File In Section: Product Recalls
 Bulletin No.: 04100
 Date: November 2004

F/CMVSS NONCOMPLIANCE RECALL

SUBJECT: HEADLAMP COMPLIANCE

**MODELS: 2005 CHEVROLET COBALT
 2005 PONTIAC PURSUIT (CANADA ONLY)**

1527179

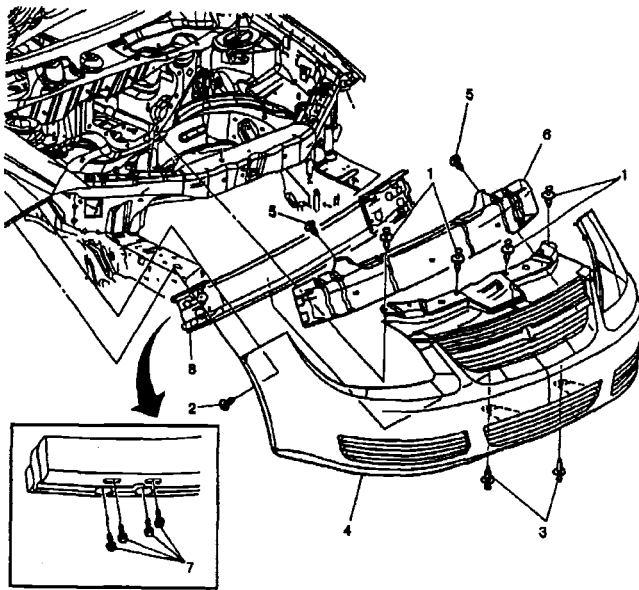
2. Remove the two bolts that attach the right headlamp assembly to the housing bracket.
